HAM PASS
ADDENDUM

Subject: GEOLOGIC REVIEW OF A PORTION OF LAND PROPOSED FOR TIMBER HARVEST

SUBJECT: Ham's Pass Timber Harvesting

Map to Accompany Geologic Map
Proposed Timber Harvest, U. S. Forest
2/17/82

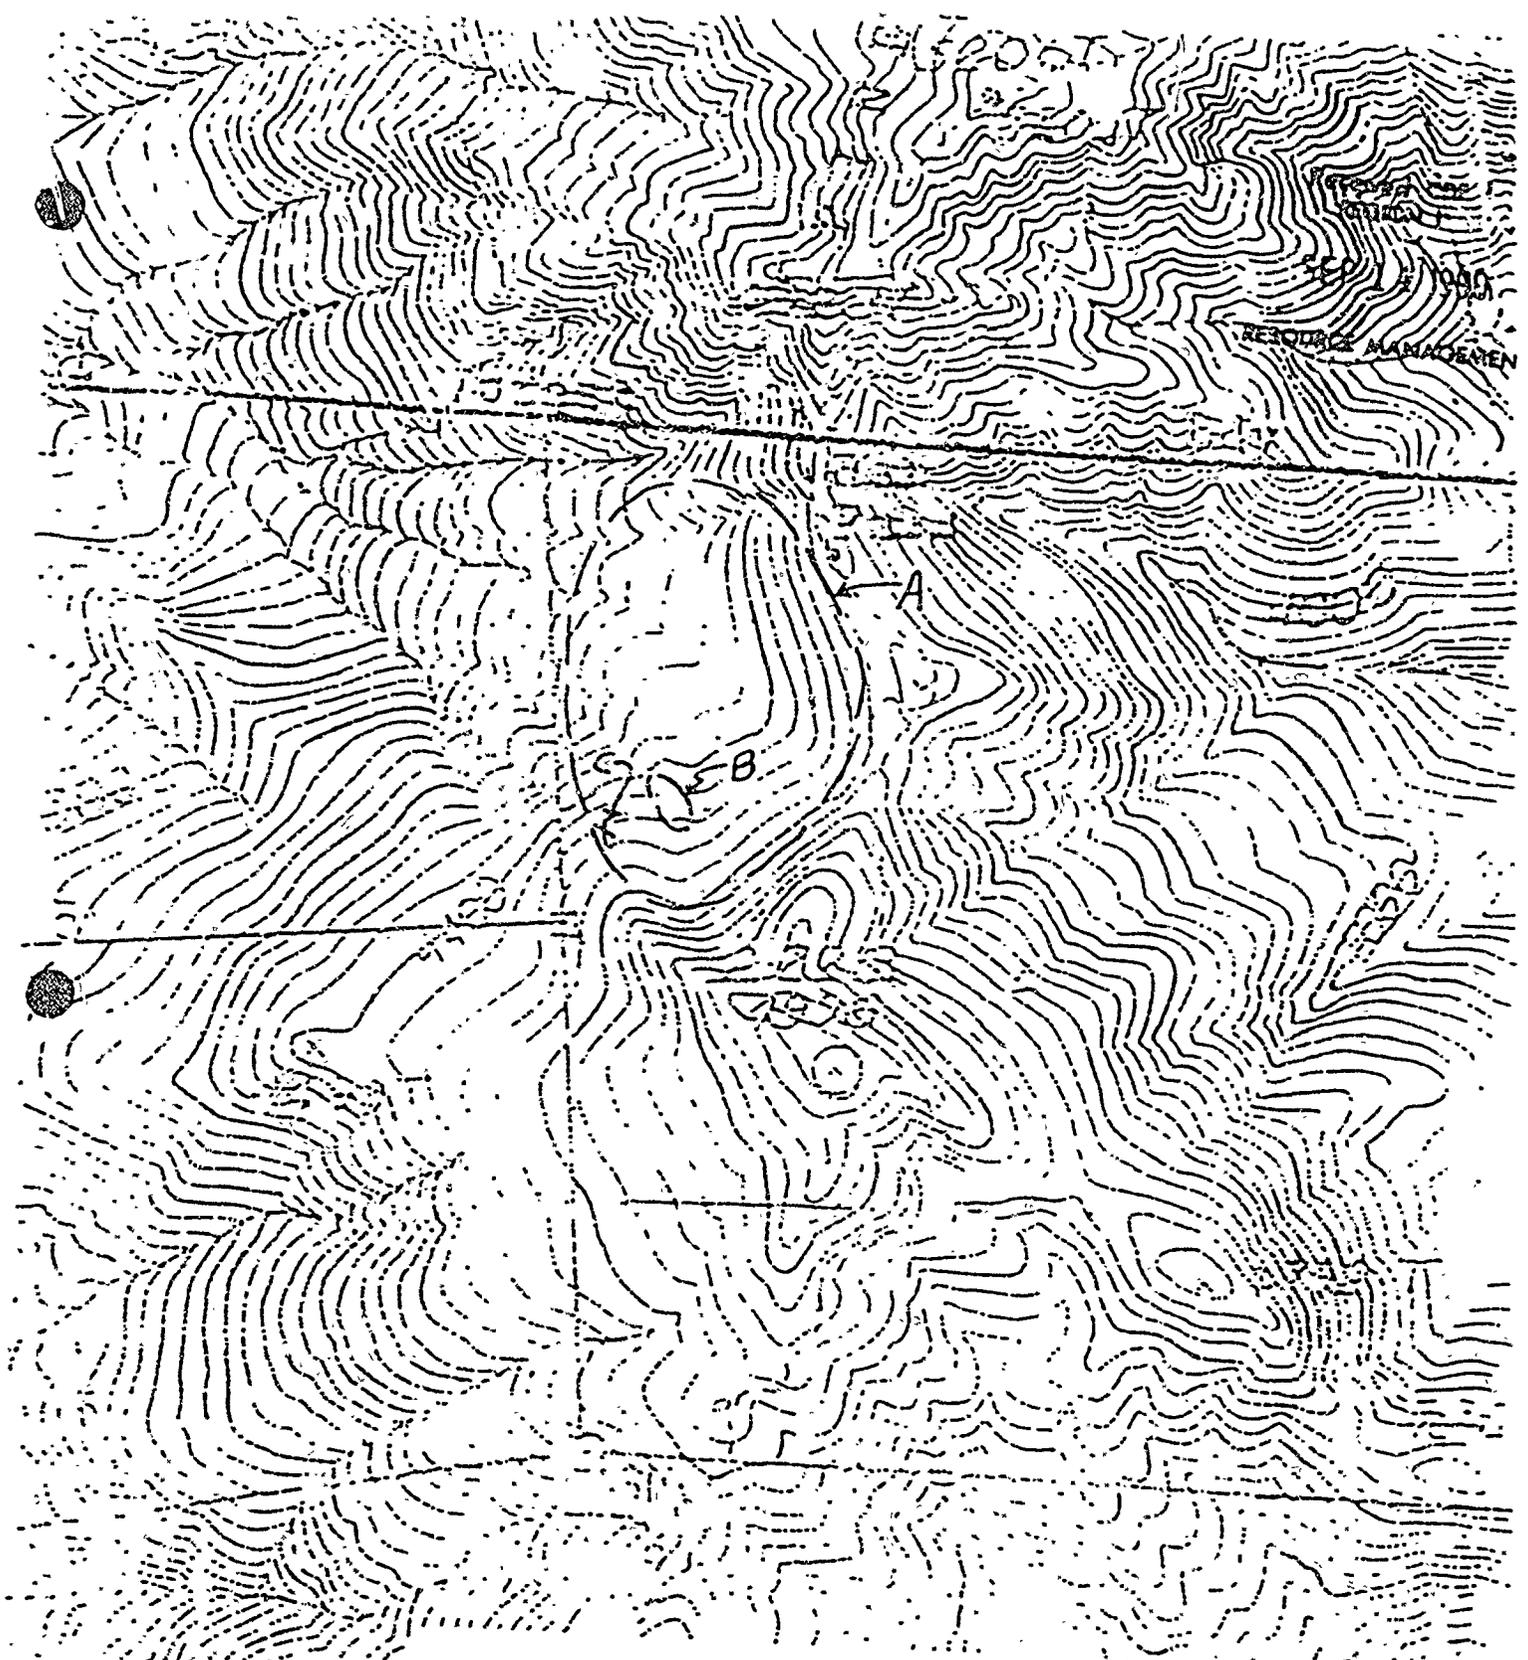
Landslides: There are three landslides, each of different age, which were observed.

- A. This is an ancient rotational slide/slump about 40 acres in size. At least two distinct episodes of movement are evident. The first, which may have been pre-Holocene, resulted in a large, thick, bench-like deposit of loose landslide debris which was subsequently deeply dissected by erosion. Efficient, V-shaped draws evolved which drained through the landslide area. A later episode of movement disrupted and terminated most of these draws by rotational movement and slumping. This last episode was clearly Holocene in age, as most of the draws are still disrupted or terminated. There are many deep, closed depressions, sag ponds, or draws ending in flats, where little or no surficial drainage occurs. Subsequent to the last episode of movement, a mature stand of timber containing Douglas-fir, sugar pine, and Incense Cedar has grown without any apparent signs of disturbance.

- B. This smaller landslide/slump of 1-2 acres in size is within the larger slide "A." It has occurred subsequent to the softwood timber stand and has resulted in a grove of nearly all oak re-establishing the ground. There are no recent signs of ground movement.

- C. This is a small (less than an acre) landslide/slump which occurred this winter (1982-83). At least three tilted or fallen fir trees were observed. There are fissures, scarps, and broken ground.

Landslides A and B:

Roads and skid trails should be constructed with as little cut and fill as possible. Skid trails particularly should be laid-out where little or no blademwork is necessary. Runoff should drain efficiently from all roads and skid trails by out-sloping, waterbars, and rolling dips. Inside ditches, inslopes and berms should be avoided on roads.

Landings should be built with as little excavation as possible - particularly cutting. Closed depressions may be filled if needed. Landings should be drained efficiently on completion.

Runoff from roads, trails and landings should not be directed into areas which do not drain, such as sag ponds or other closed depressions.

Furthermore, the stability of this area can be generally improved if sag ponds, closed depressions and flats are drained. A small bulldozer or backhoe could cut channels after the operation.

Landslide C:

Down and leaning timber can be removed from this area without further excavation.

Landslide Map Ham Pass area

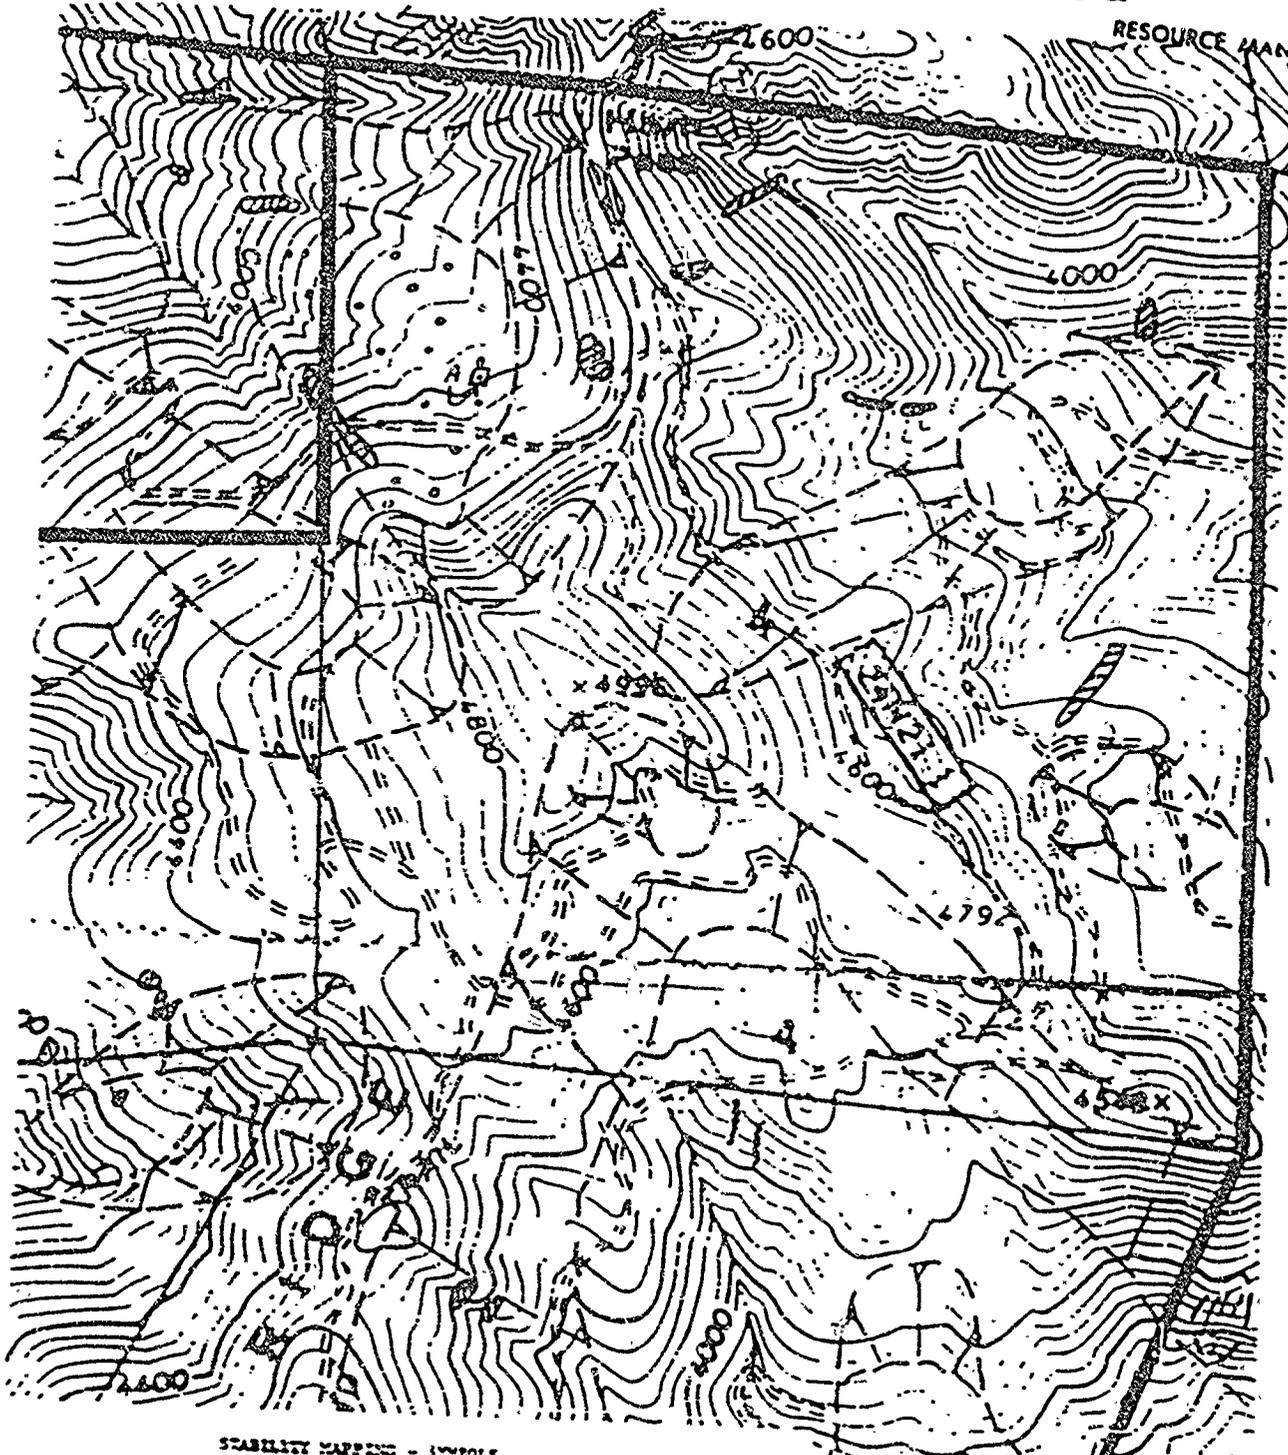
Numerous dormant landslides were mapped (see enclosed map) in both the unlogged as well as the previously logged area in addition to active landslides in both of the areas. The 1984 aerial photographs showed several active landslides not visible on earlier photographs. However, these may have been observed partly because of the larger, 1:12,000 scale photography of the 1984 photographs. These landslides did not appear to be related to prior logging activity although some may have been due to road construction.

One noticeable area of instability which is of great importance to timber management is the area along the western edge of Section 4. The road there crosses a large slide that extends both uphill and downhill from the road at approximately 4400 feet elevation. This slide, approximately 100 feet wide trends SE-NW 145-325 degrees and extends outside the harvest boundary downhill and over 1000 feet uphill. North of this road the ground is hummocky with numerous closed depressions which store water in ponds during wet periods and recharge the groundwater. Large deep gullies occur within the area mapped from aerial photos as multiple nested landslides. Some of these gullies developed from a swale over a short distance and may be the result of stream flows over disrupted, easily erodible landslide material.

North of the spur road in the area proposed to be harvested a large boulder strewn stream channel occurs at the area marked "B". The origin of the large boulders was not determined but could be the result of faulting or an unstable area uphill from the site.

A proposed logging access road departs from the spur road at about 4440 feet elevation. About the marked location (A) the road will cut into a slight scarp. Any cutting into the hillside at this point will probably initiate renewed mass wasting. The road should either be filled at this point or the road should be relocated below this critical point.

The area noted as an active landslide in the SW1/4 NW1/4, Section 4, T.23 N. R.11 W., should not be harvested for a hundred feet on either side of the center line of the landslide. This width of non-harvesting will give root support to the margin of the slide as well as assisting in reducing ground water table by transpiration.

The timber has already been marked within the area and several trees that have been marked are providing bank support and stability in an easily erodible area. A hydrologist or geologist should be allowed to paint over the marked trees to preserve stability and maintain erosion at an acceptable level.

Addendum item #47

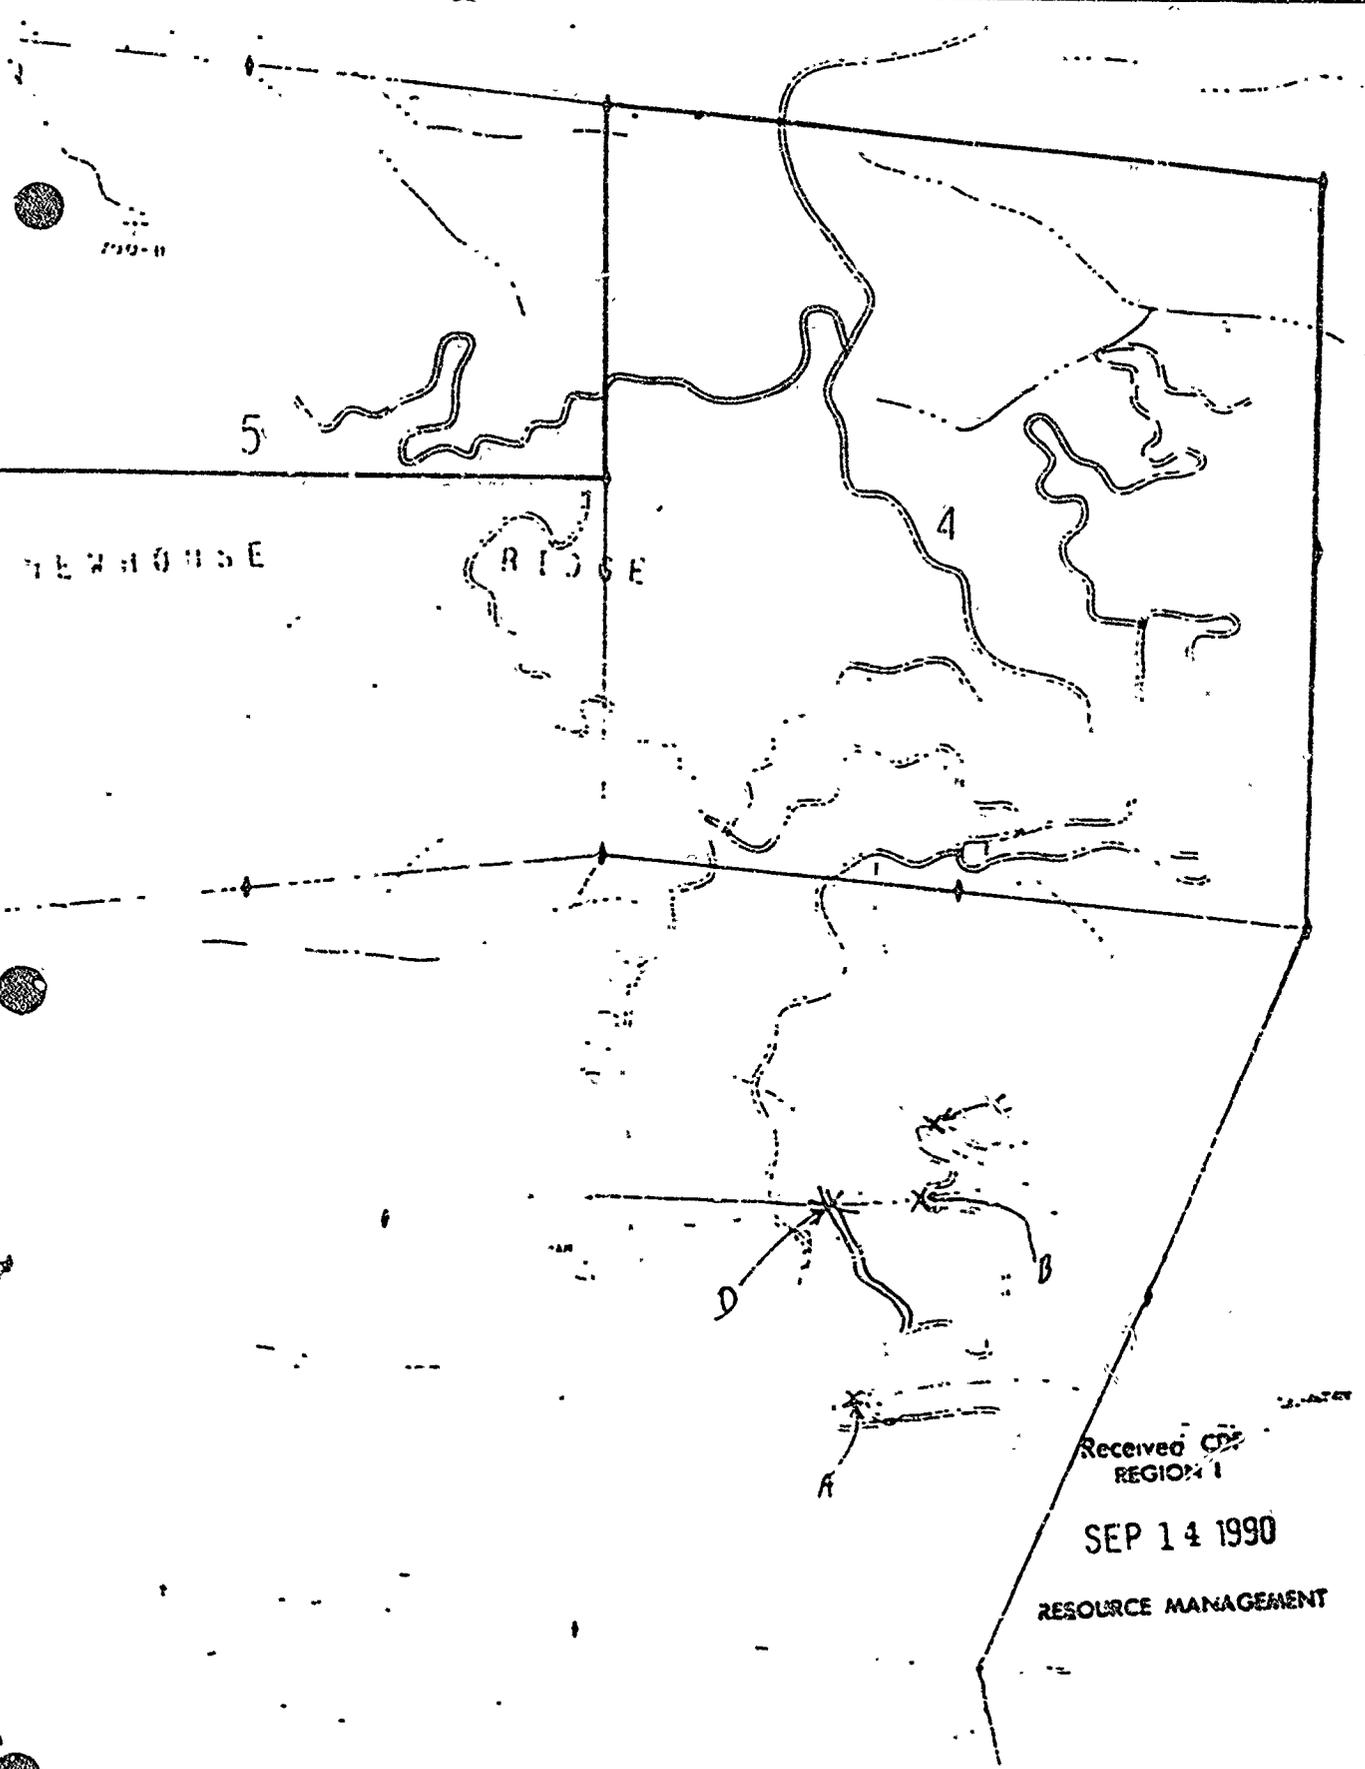
I also talked to him about the stream crossings in Section 9. He concurred with the Humbolt crossing above the water hole, (Marked A on attached Map). He said to put plastic over the logs before covering them with dirt. On the second stream crossing, (marked B), he had no problem with a backhoe digging out in front of the existing culvert, if it meets 50 years flood requirements, to redirect the water back into said culvert and dropping the road bed in order to cover the culvert. On the 3rd crossing, (Marked C), he has no problem with either a Humbolt Crossing or moving the existing culvert in the stream channel and lowering the road. The 4th crossing, marked D, he had no problem with a Humbolt crossing with plastic covering the logs before the application of soil.

I asked him his opinion on the need to preserve the over mature timber in the SLPZ up and down stream from the crossing marked B. He said these trees made up only 5% of the canopy protecting the stream and he had no problem with their being harvested. He did ask that those trees obviously cull be left along with the snags.

47. Along the WLPZ at the stream crossing marked B the decadent overmature timber in the over story will be removed. DFG Biologist Wooster said this timber made up only 5 percent of the canopy protecting the stream and could be removed. (see attached memo)
